Design Excellence Panel Minutes

Application No: DA2021/0152

Property: 2-36 Church Street, Lidcombe

2-36 CHURCH STREET LIDCOMBE
DESIGN EXCELLENCE PANEL PRESENTATION

GROUND ACTIVATION PLANE DIAGRAM

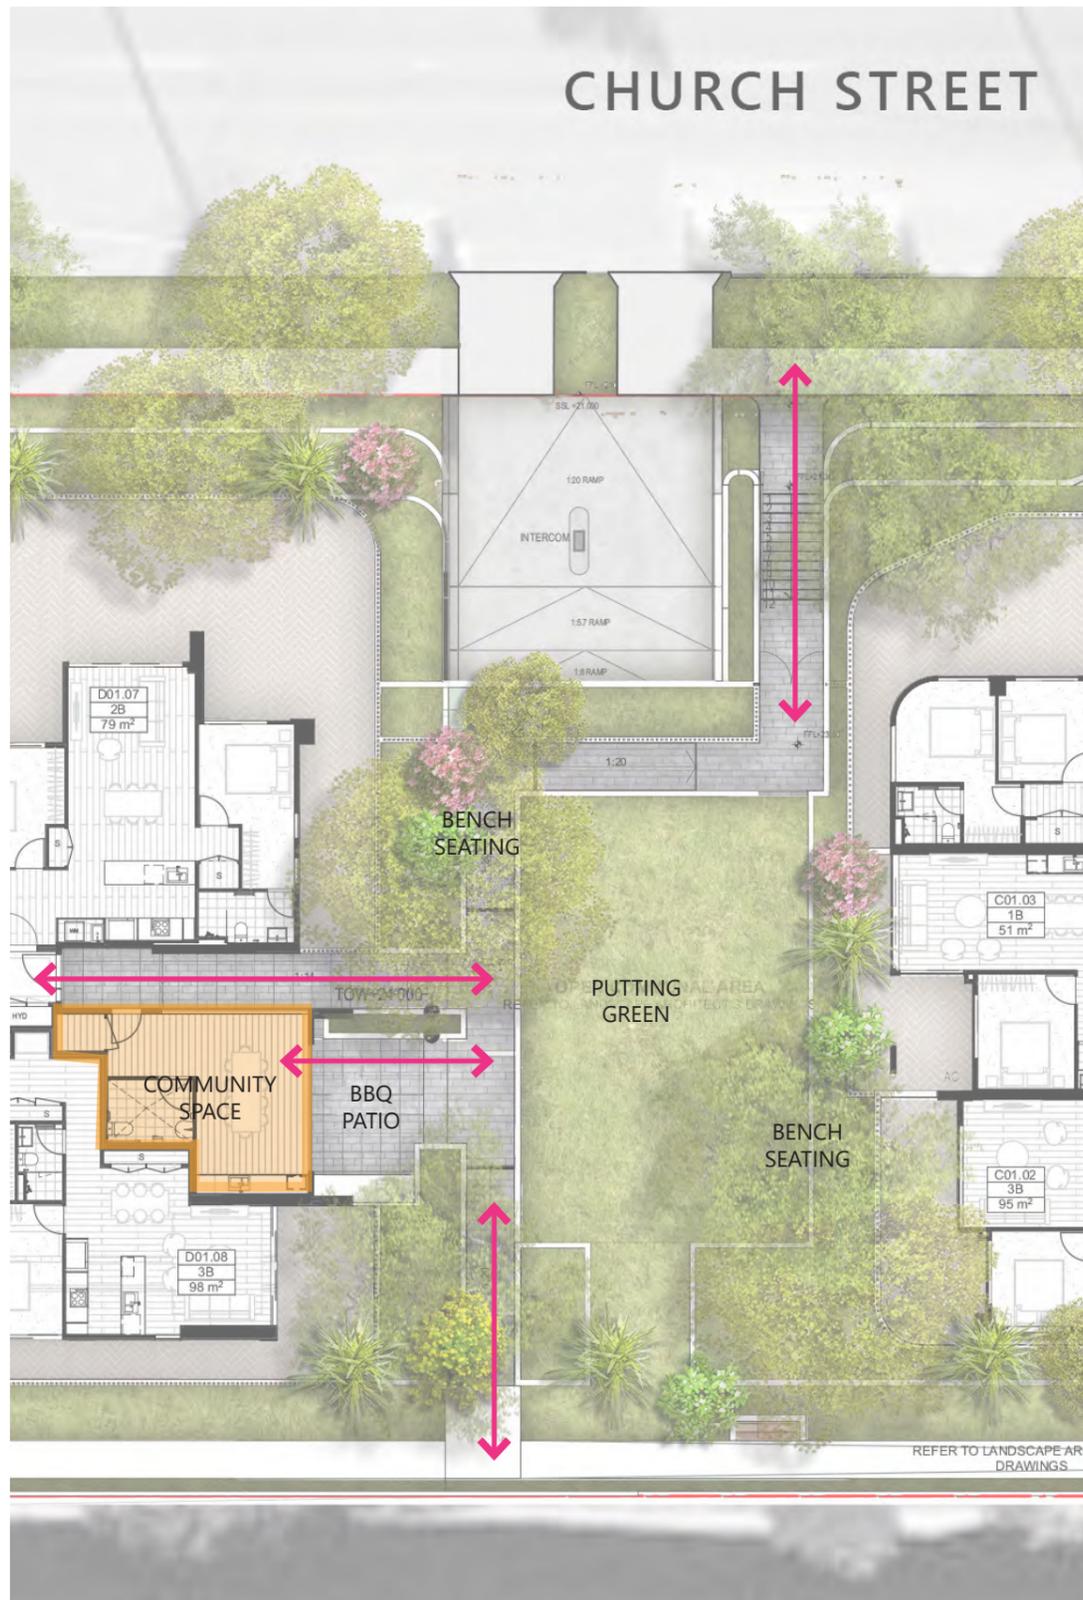
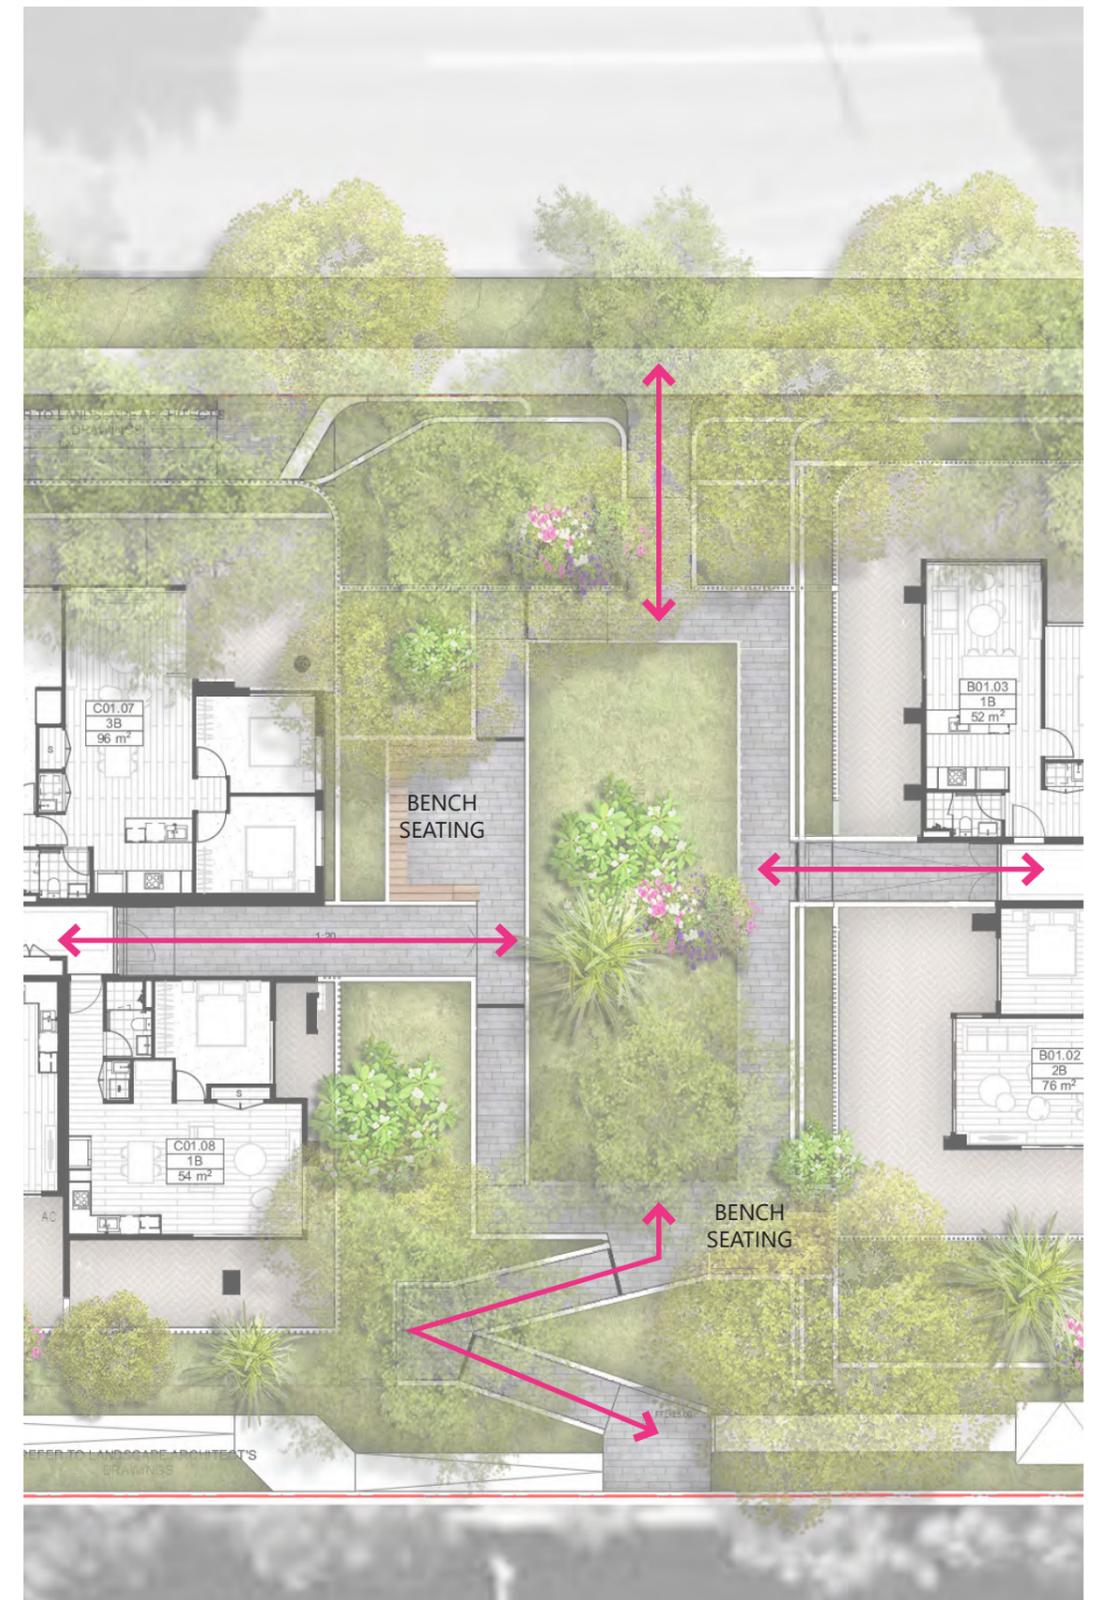
- 1.2 The Church Street frontage is a major conduit and gateway into the Lidcombe town centre, and should help establish an attractive and activated public domain. This requires further detail design and consideration of how the podium base to each of the four buildings can be improved with appropriate interfaces that will support proposed neighbourhood retail, common entry spaces and social interaction.

The design is intended to provide an activated frontage to Church St, with a diverse mix of proposed uses for the base of the tower forms supplemented by generous setbacks and a carefully considered landscape strategy to ensure a public domain that contributes positively to the life of the street as well as providing an appropriate marker into the Lidcombe town Centre.

An Activation plane diagram has been provided below to illustrate how the podium is intended to function, highlighting the diversity of uses proposed, the extent of public vs private space,

An internal community space has been provided at the base of Building C. Intended for use as a communal lounge that could be specifically booked to host larger gatherings, its inclusion provides for greater flexibility for the development's residents. It has been strategically placed to be directly adjacent and open out to the landscaped communal area between Building C and D.

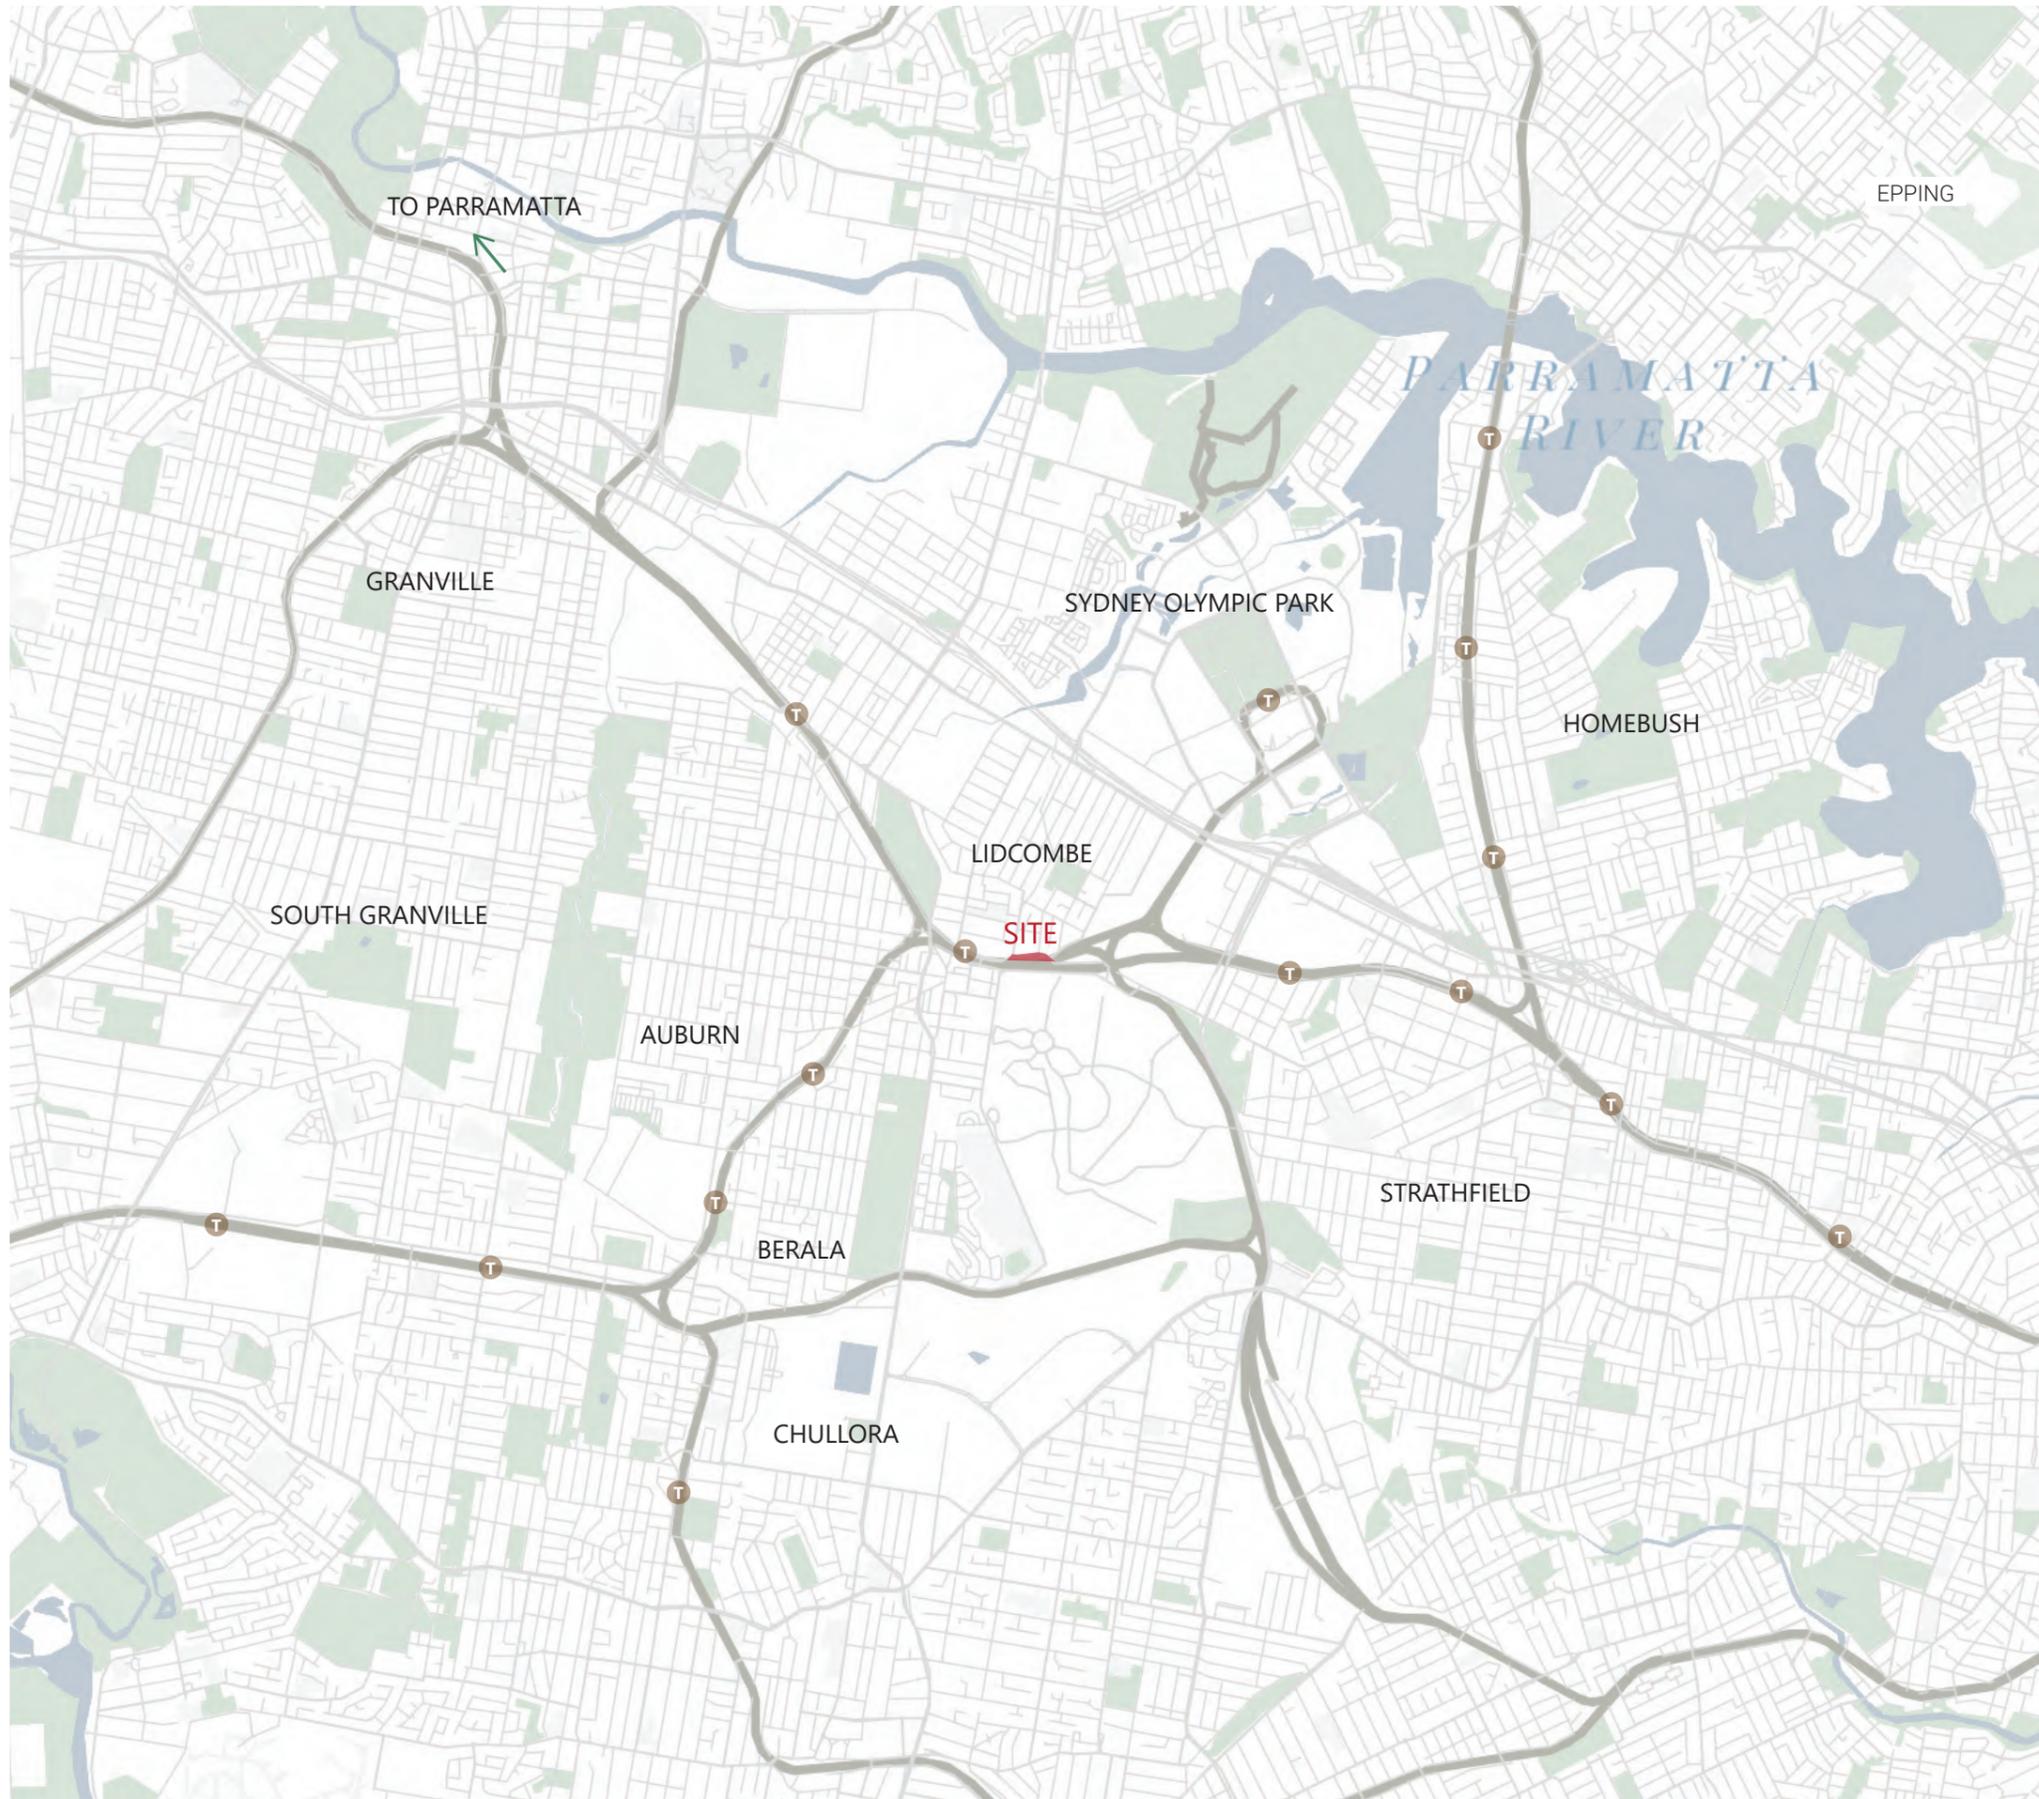
5.1 The Day Care centre is a positive contribution to the development, but inclusion of appropriate privacy screening from above and the perimeter must be considered together with scope for soft landscaping, acoustic and solar protection.

The design of the outdoor areas associated with the childcare centre have been further developed with regard to the issues of acoustic privacy and solar protection. Inclusions of 1.8m fence screening along the perimeter, pergolas and awnings will provide additional privacy and added acoustic and solar protections.
